VERSION WITH MARKINGS TO SHOW CHANGES MADE

Applicants:	Richard A. Cronenberg and Dennis Mitchell
U.S. Serial No.:	09/873,842
Filing Date:	June 4, 2001
For:	**AUTOMATIC PIPETTE IDENTIFICATION AND DETIPPING**
Examiner:	Not Yet Assigned
Group Art Unit:	1744

LETTER WITH PROPOSED DRAWING CHANGES

FIG. 2A

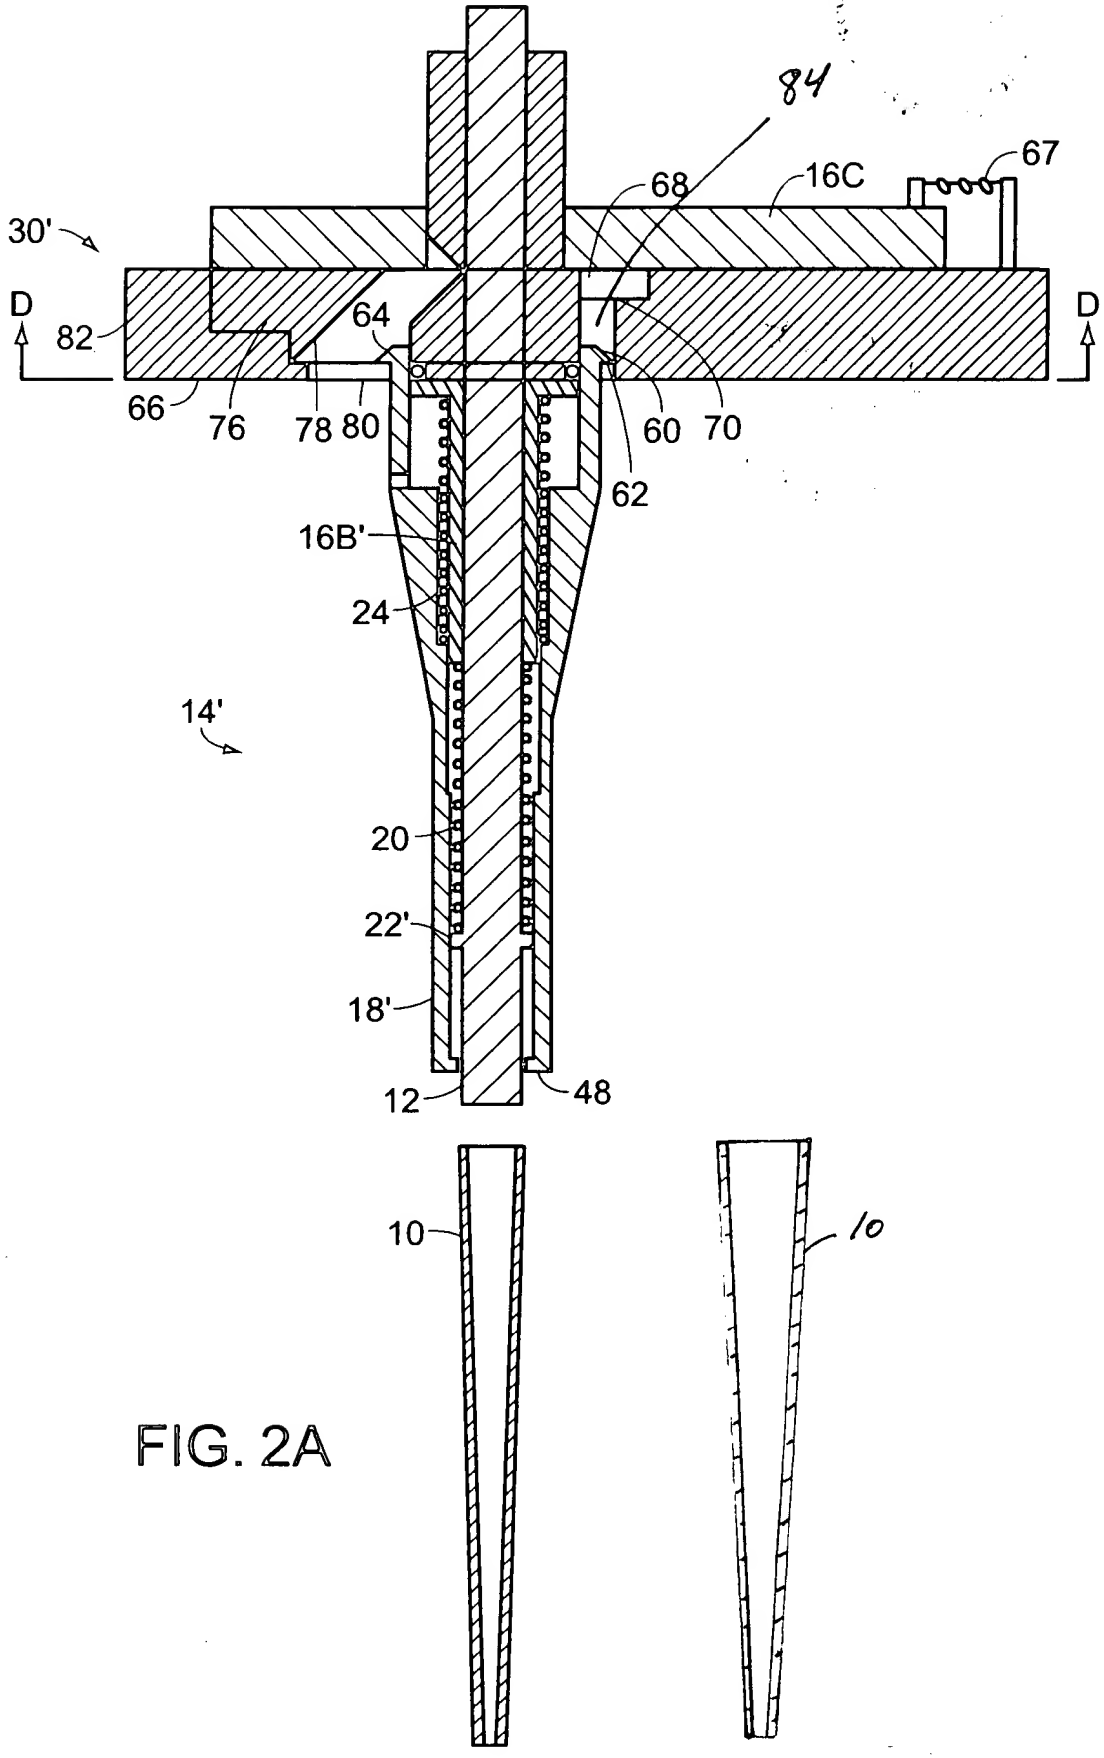
More specifically, Applicants have amended: Fig. 2A to include numeral --84-- and to widen an end of tip 10 in order for tip 10 to fit on nozzle 12; and Fig. 2B to remove lines in the center of latch 30' and to widen an end of tip 10 in order for tip 10 to fit on nozzle 12. For the sake of clarity, Applicants have also redrawn Fig. 2C to add numeral --78-- and a line referenced by numeral 78, to add tension spring 67, to lengthen plate 66, to add numerals --64-- and --16C--, and to widen an end

FIG. 2C

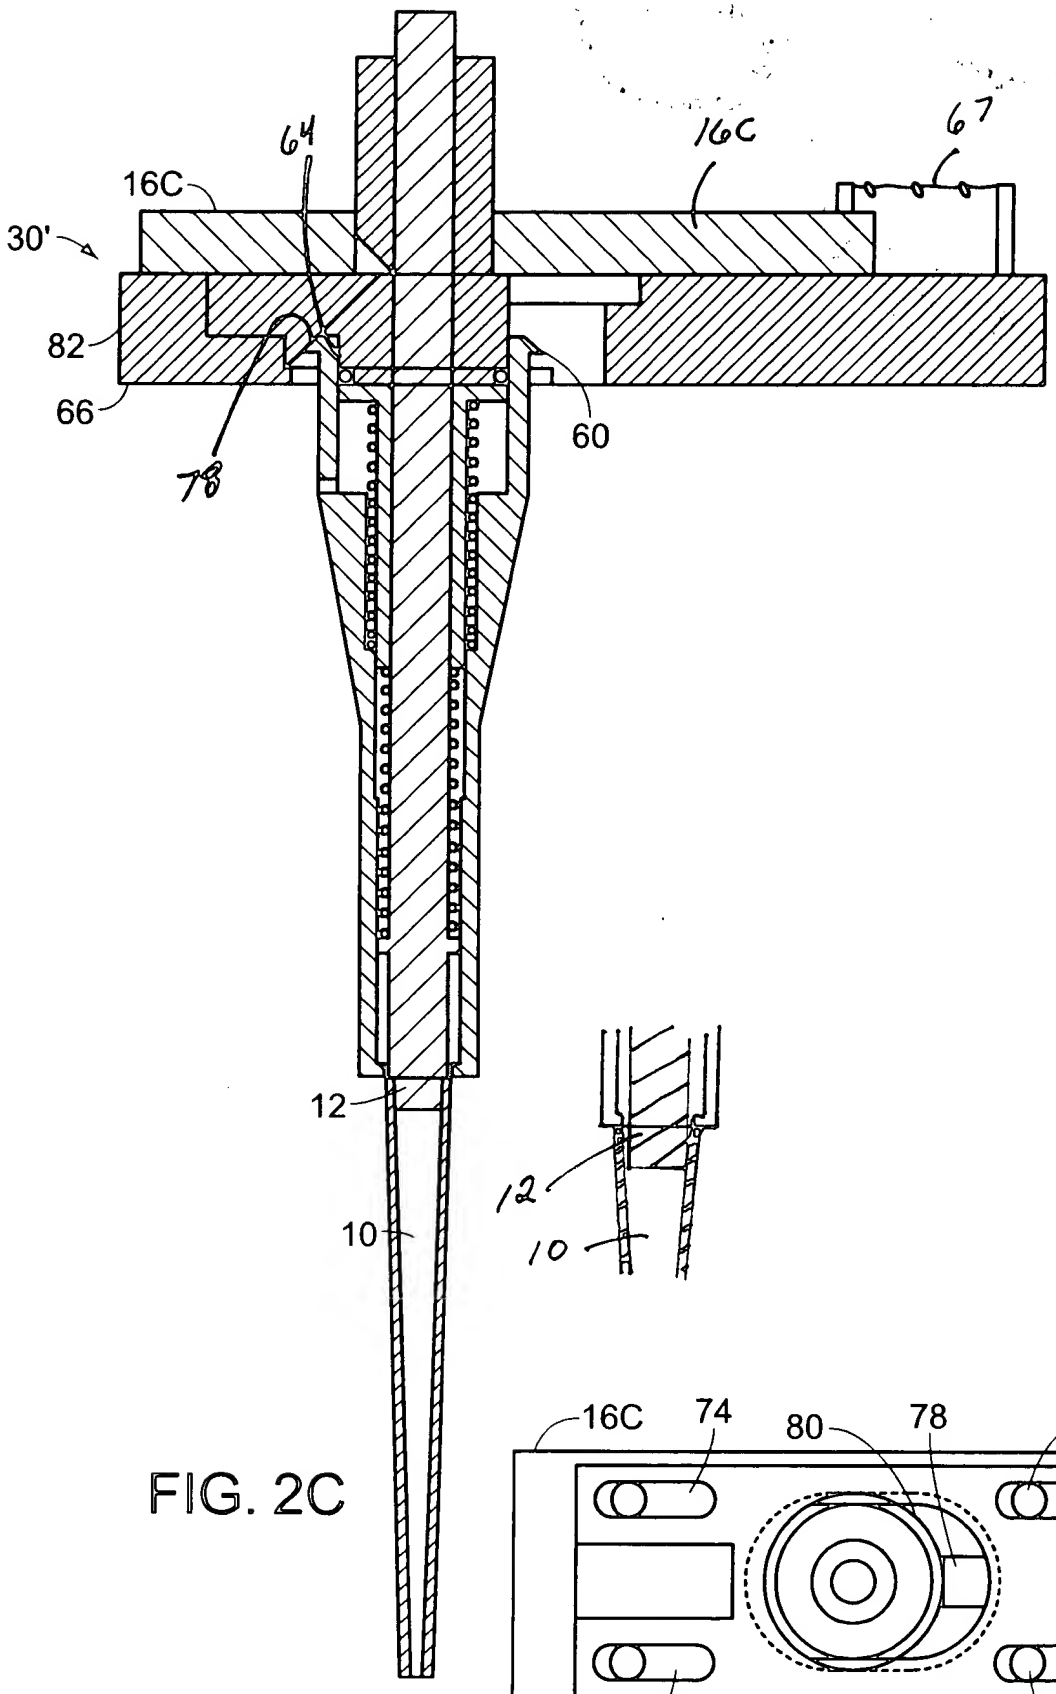
of tip 10 in order for tip 10 to fit on nozzle 12. These and some additional minor changes were made to Fig. 2C to be consistent with Fig. 2B. Fig. 3B has been amended by changing numeral "18" to --18'--.
